## Product Change Notification / LIAL-02EMAI368

CCB 3886.005, and 3886.006 Final Notice: Qualification of MMT as an additional assembly site for selected Microsemi products available in 28L VQFN (4x5x1mm) and 16L VQFN (4x4x1mm) packages

# CCB 3886.005 and 3886.006 Pre and Post Change Summary PCN # LIAL-02EMAI368

28L VQFN (4x5x1mm) package

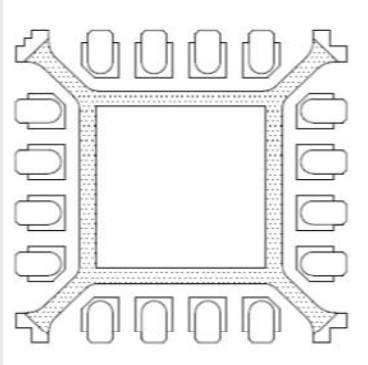
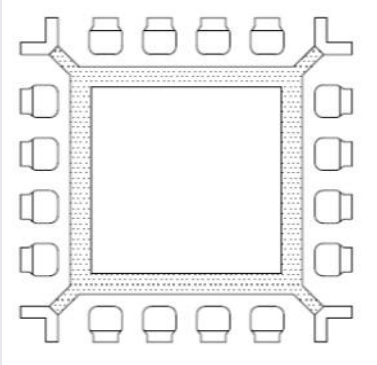
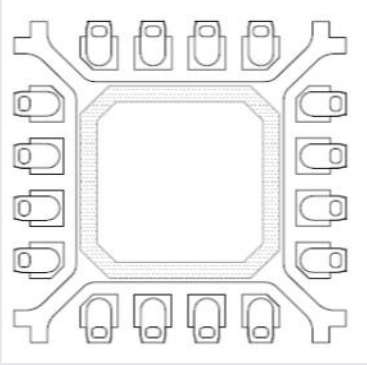
<table border="1"> <tr> <td>Paddle size</td> <td>114x154 mils</td> </tr> <tr> <td>DAP Surface Prep</td> <td>Ag Ring Plated</td> </tr> </table>	Paddle size	114x154 mils	DAP Surface Prep	Ag Ring Plated	<table border="1"> <tr> <td>Paddle size</td> <td>102x142 mils</td> </tr> <tr> <td>DAP Surface Prep</td> <td>Ag Ring Plated</td> </tr> </table>	Paddle size	102x142 mils	DAP Surface Prep	Ag Ring Plated	<table border="1"> <tr> <td>Paddle size</td> <td>114x154 mils</td> </tr> <tr> <td>DAP Surface Prep</td> <td>Ag Selective Plating</td> </tr> </table>	Paddle size	114x154 mils	DAP Surface Prep	Ag Selective Plating	
Paddle size	114x154 mils														
DAP Surface Prep	Ag Ring Plated														
Paddle size	102x142 mils														
DAP Surface Prep	Ag Ring Plated														
Paddle size	114x154 mils														
DAP Surface Prep	Ag Selective Plating
